ADDENDUM NO. 6

DATE: February 6, 2026
FROM: City of Grand Junction Purchasing Division
TO: All Offerors
RE: Crosby Avenue Improvements Project IFB-5805-26-DD

Figure 3.4 Weekday Diurnal Pattern

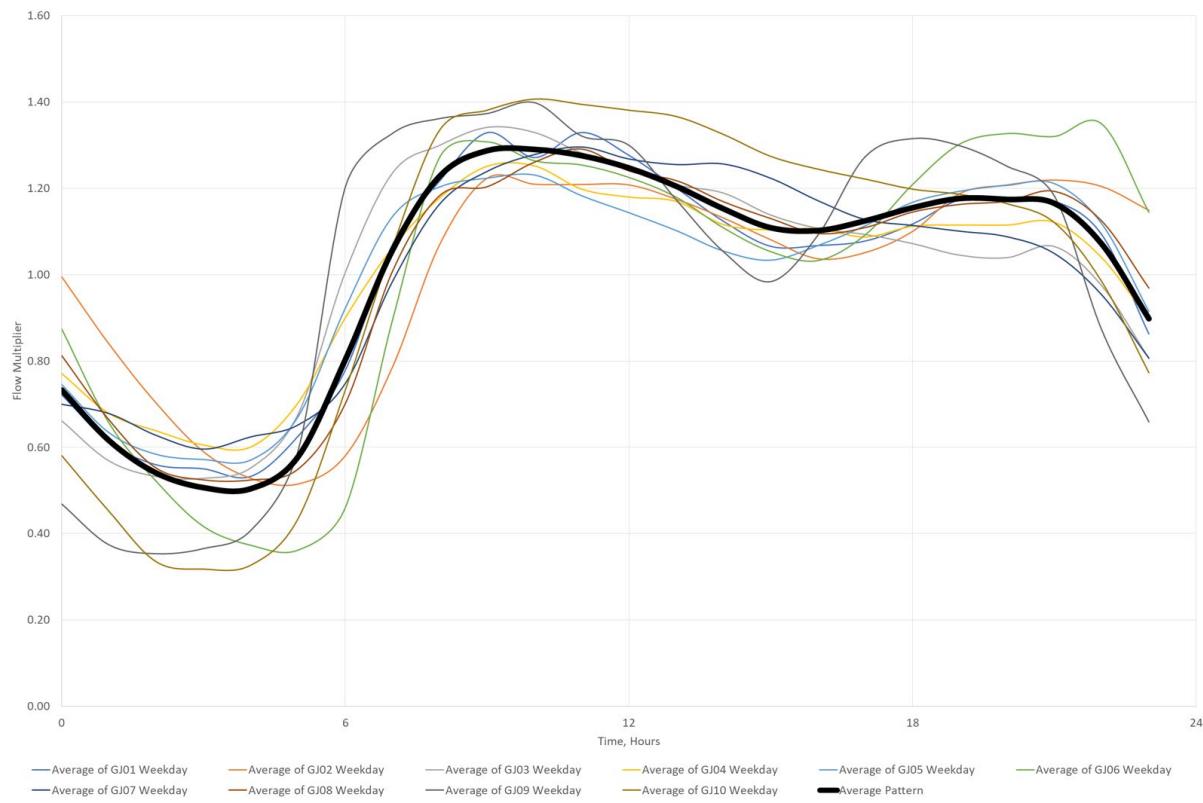
1. Question: For line 38 — **Temporary sanitary sewer bypass for MH D2-252-026** — is there any available flow data on those lines? There appears to be substantial flow in the two lines feeding that manhole, and I want to make sure we fully understand the bypass requirements.

Answer: The City's flow monitoring data for manhole D2-252-152 (across the UPRR tracks) from 2020 is attached. The Contractor shall provide redundancies to accommodate equipment failures.
